The following are the PLANS that have been derived of the ORIGINAL structure of the Byrne-Reed House after preliminary investigation. Detailed investigation is ongoing.

## ORIGINAL FIRST FLOOR PLAN

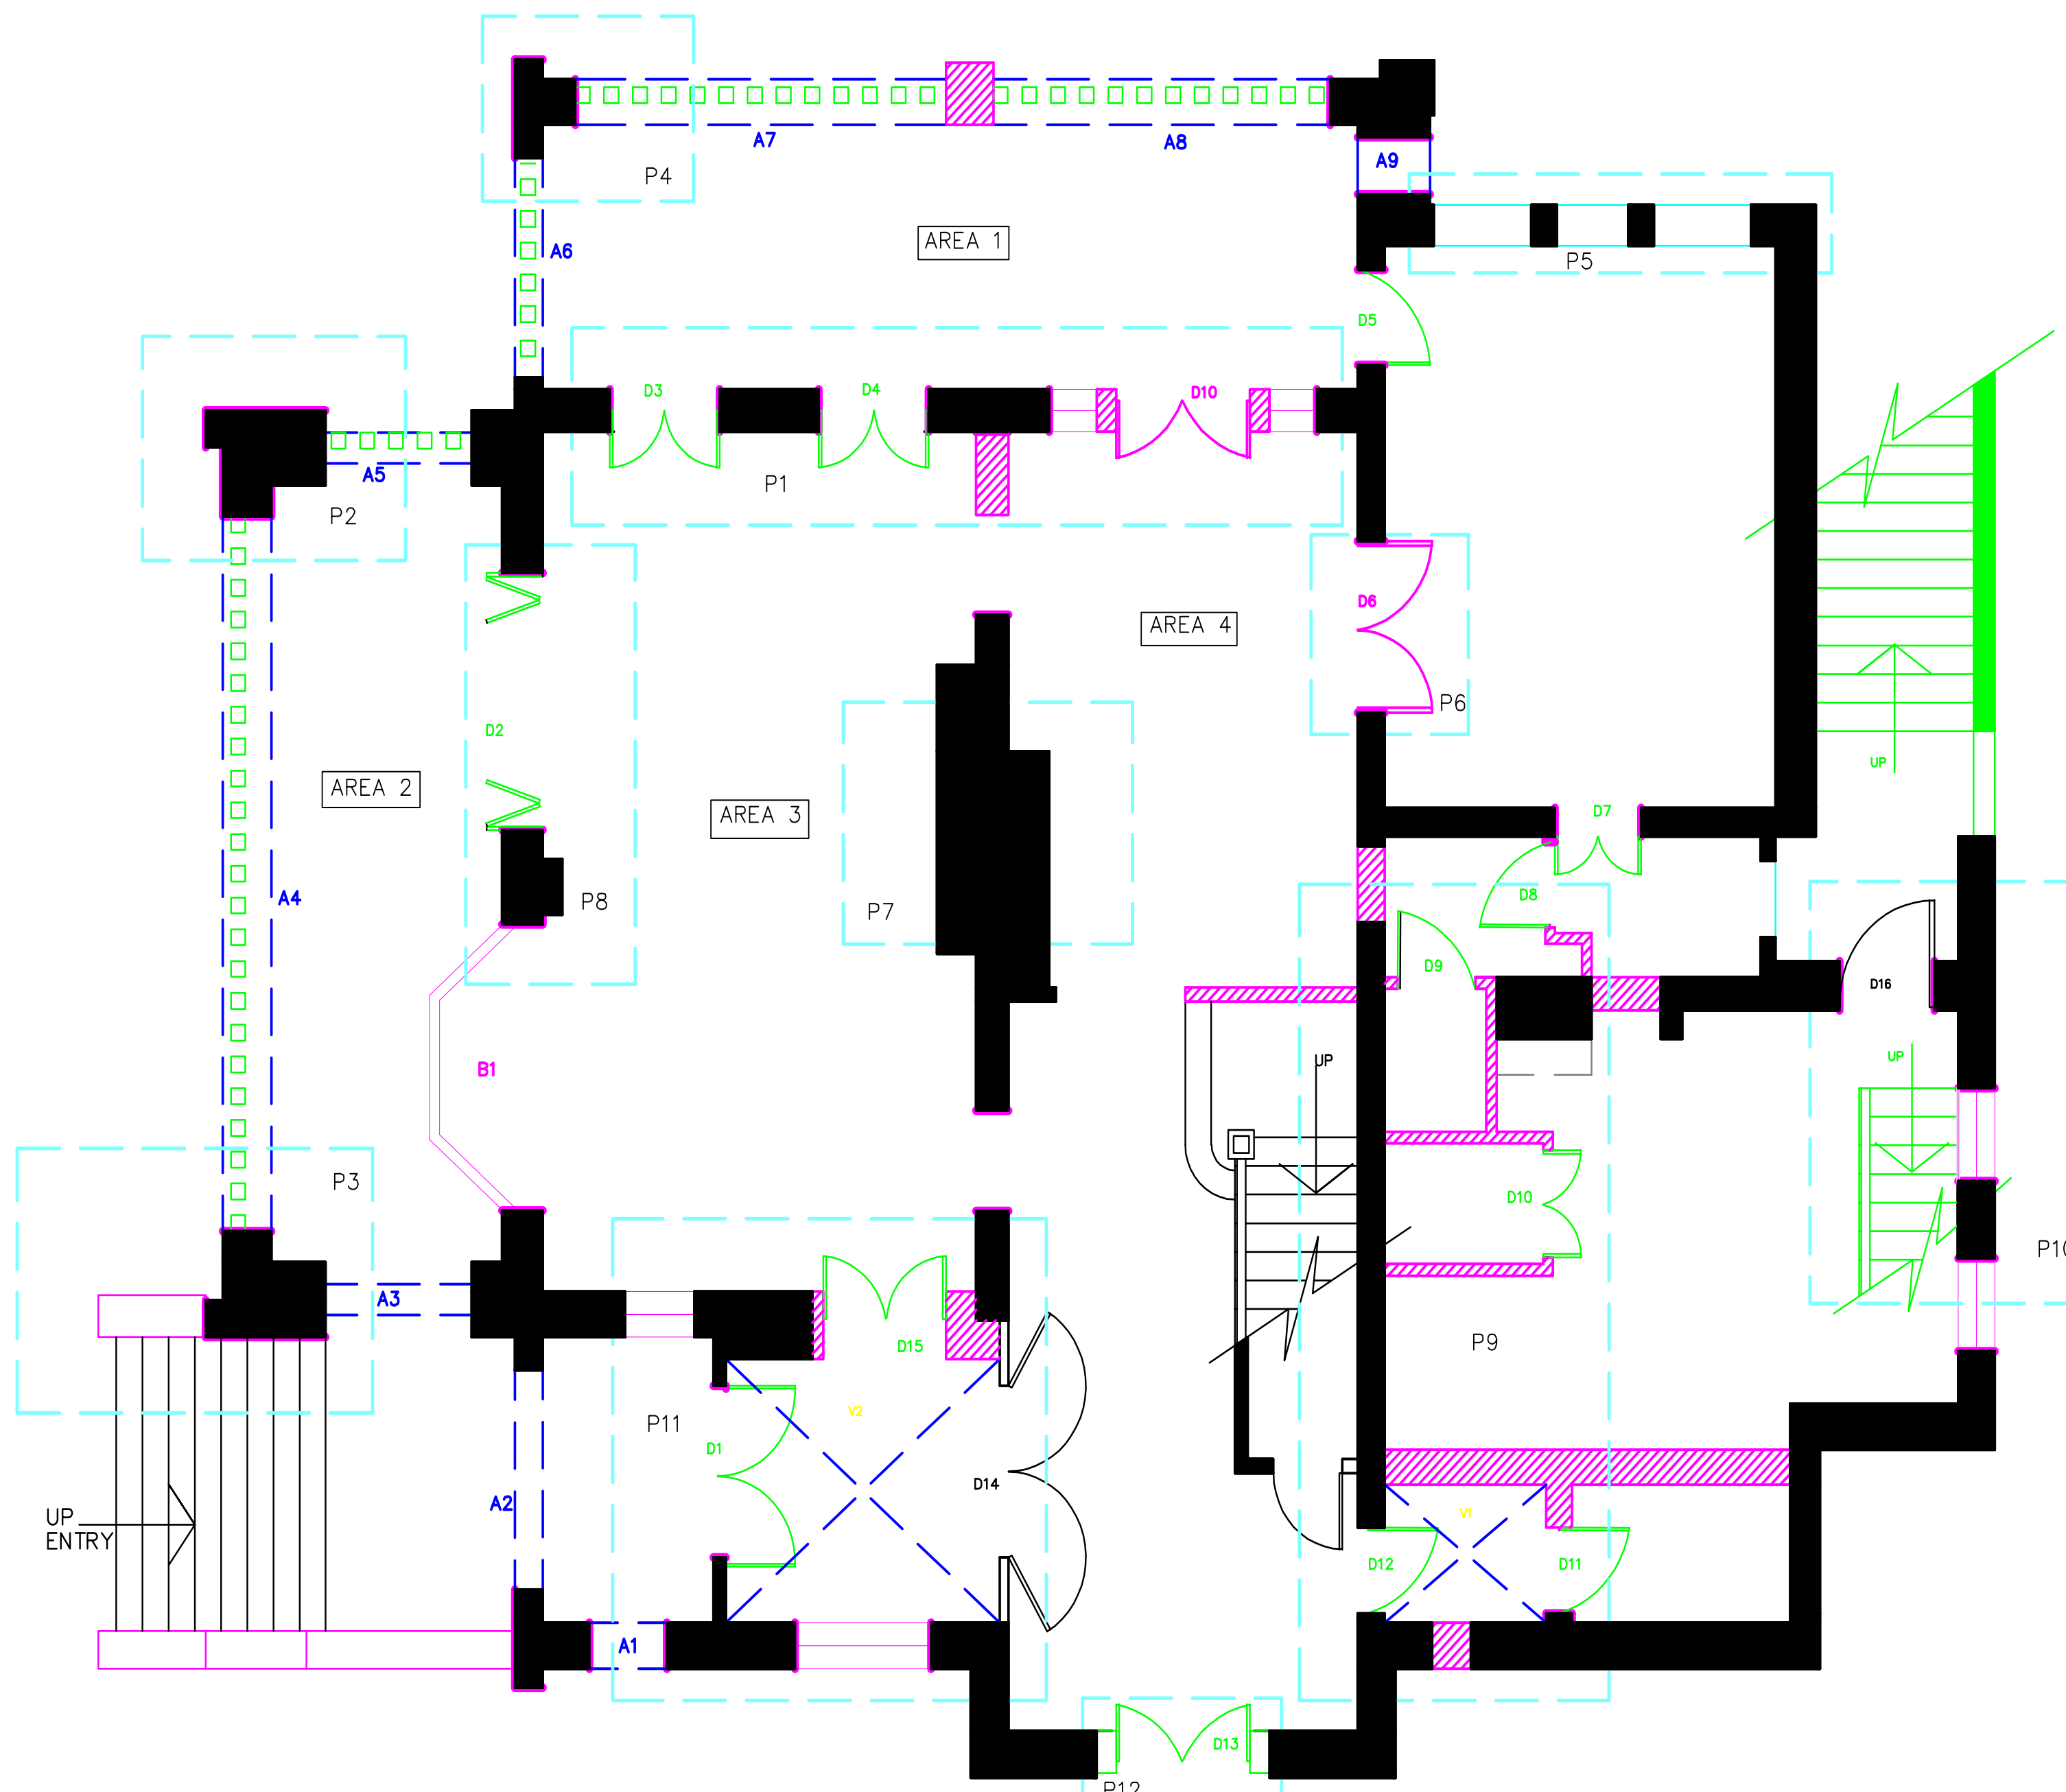
- P1-Green had been doors ripped off. Magenta door evidence exists-needs replacement to original.
- P2 /P3/P4-  
-Small Arch embedded in the existing wall. Big arch most likely removed.

- P5-Existing lighting not original.
- P6-Evidence of original door in the found. Existing door needs replacement.
- P7-Two fireplaces. Not accessible above false ceiling for further investigation. But seem to have some evidence embedded in the duct area.

- P8-Wall is thicker. It could be due to structural reasons. Investigation needed. Door opening size is fixed but the characteristics of the door shutters etc. are not known.

- P9- Completely ripped off the original structure. Needs many alterations and additions as shown in the plans. Original fireplace next to it is missing. Needs investigation. Two walls need to be shortened to 3' 0" in height. Light fixture in the center of the vault is missing.

- P10-A staircase may have existed. There is some evidence of it.
- P11-Missing light fixture at the center of the vault. A small arched window and another window from the original structure are missing from external wall. Some original doors ripped off.

- P12-D13 was not original entrance. D10 may to be equal to D13.

## ORIGINAL SECOND FLOOR PLAN

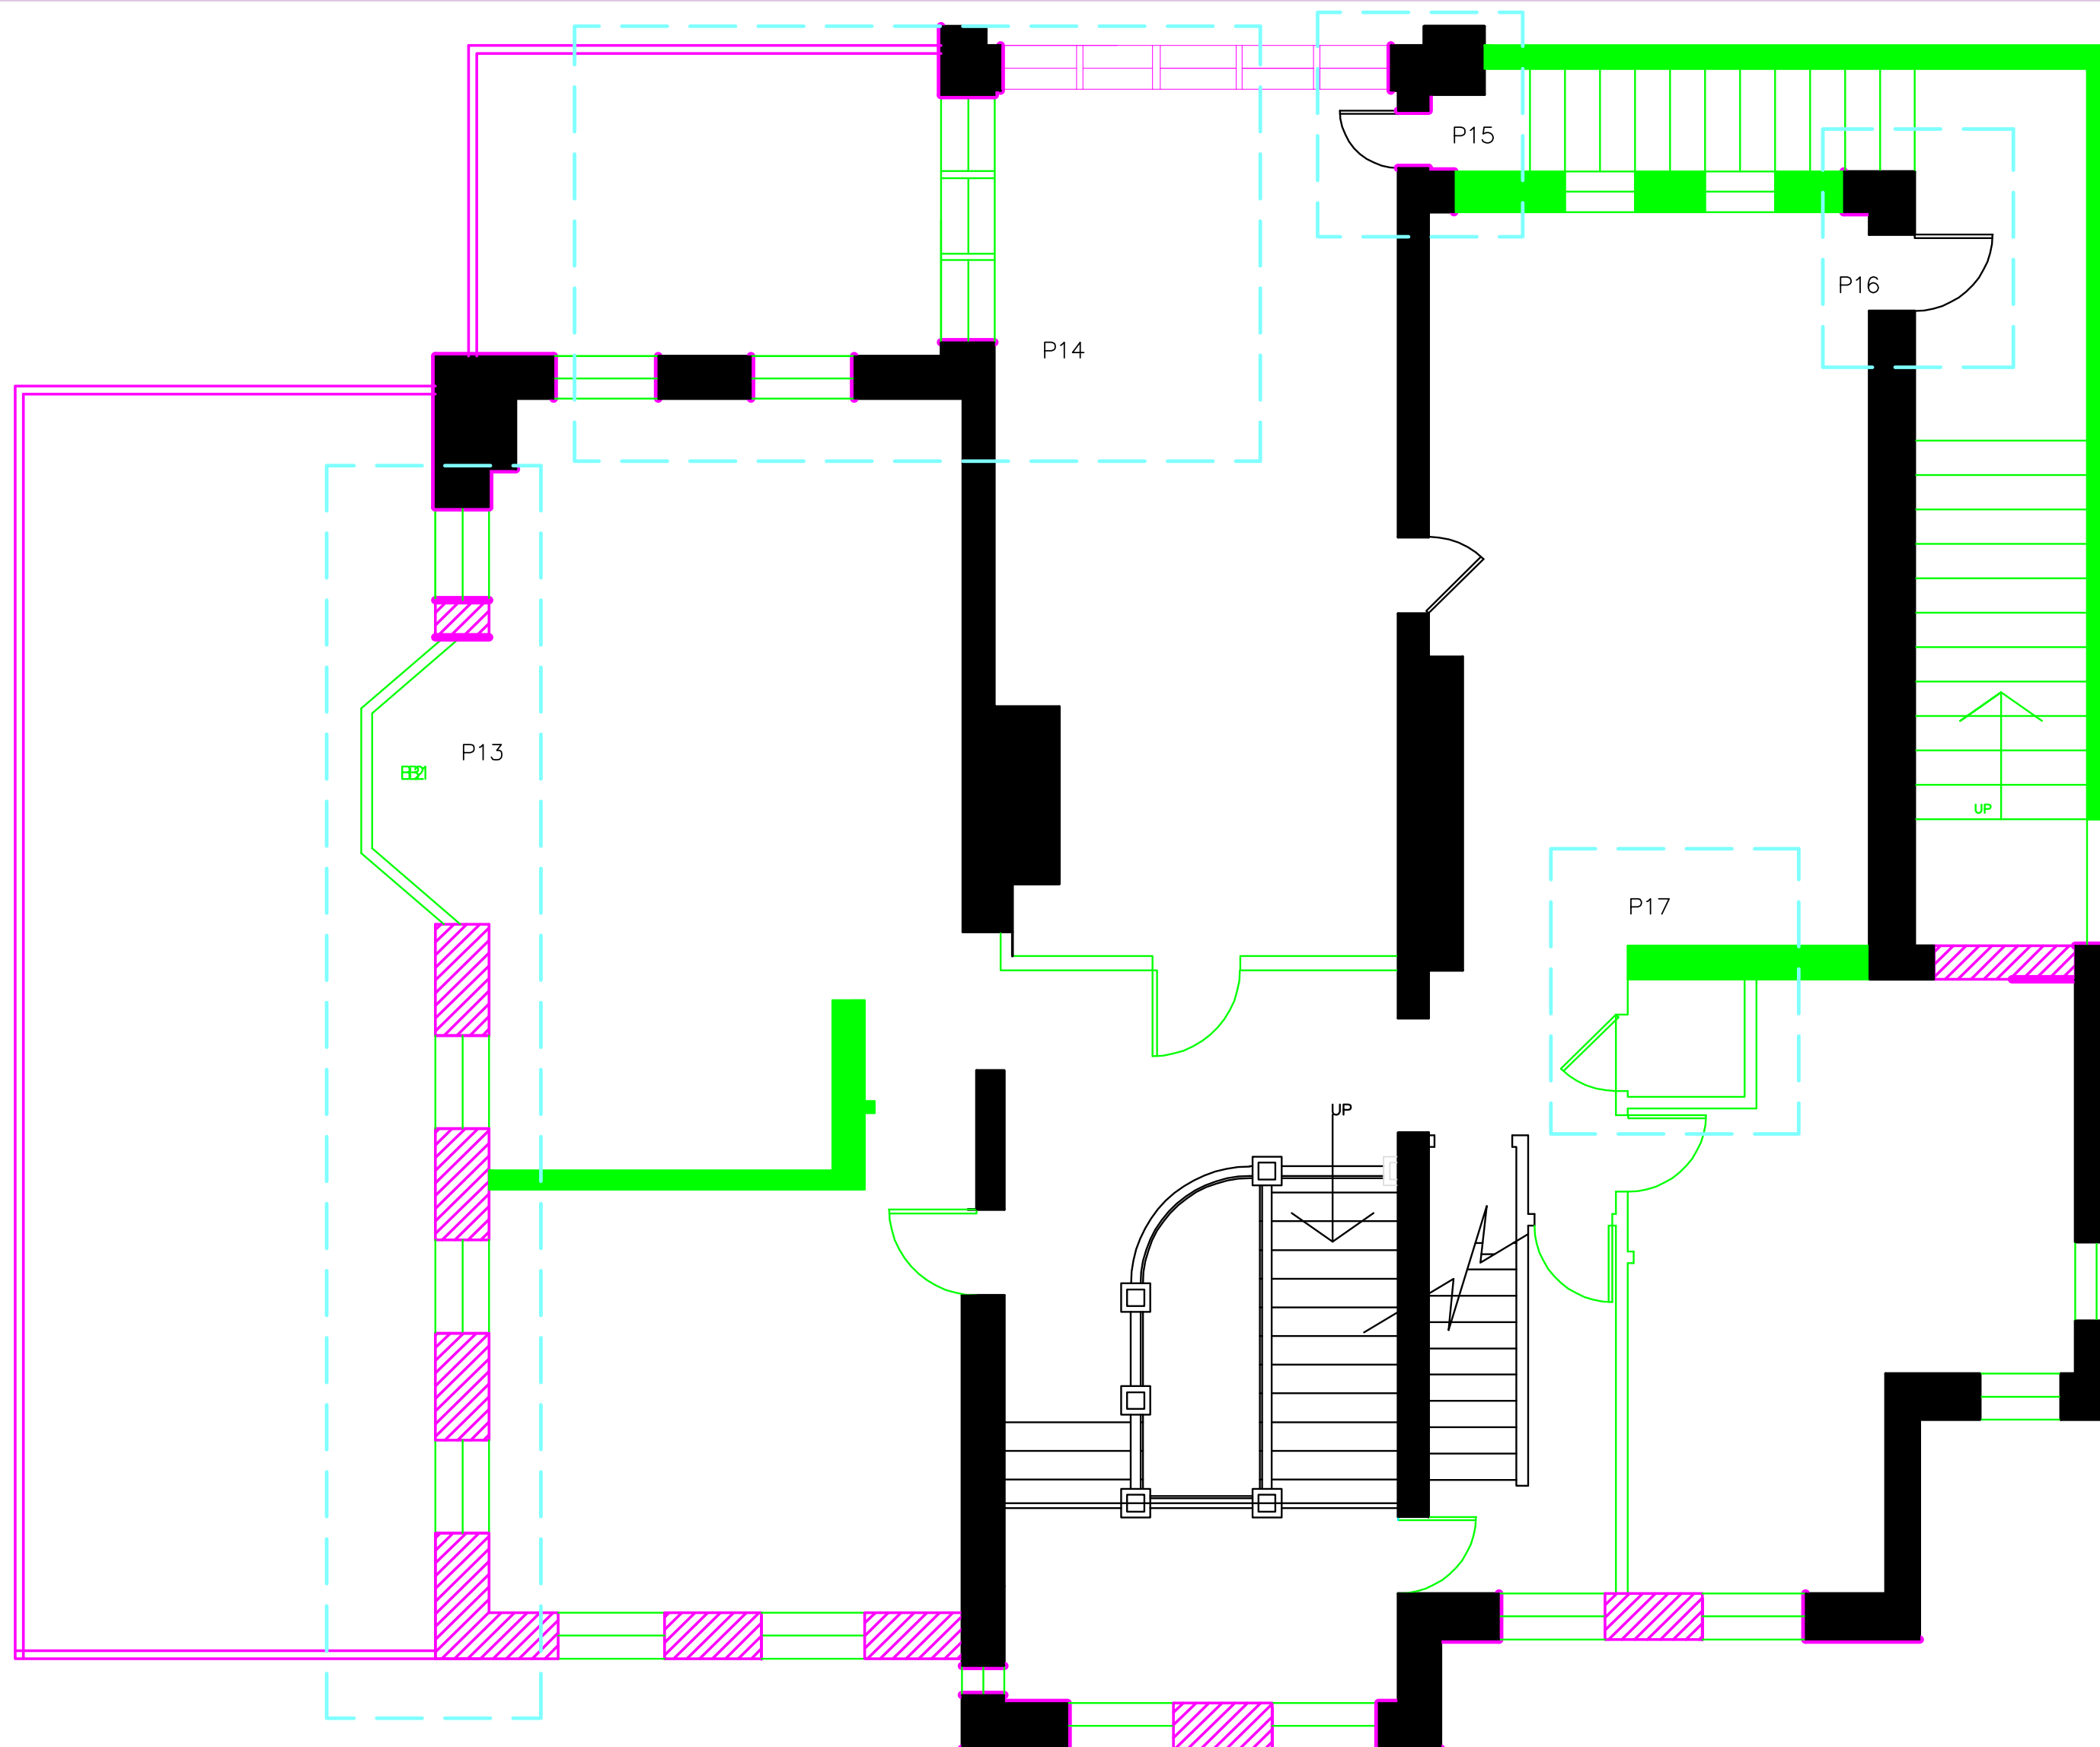
- P13-Scanty evidence of bay windows and other windows. Needs more investigation.
- P14-E boards and acoustical tiles glued.
- P15/P16-Evidence of doors indicating that there may have been a fire escape staircase.
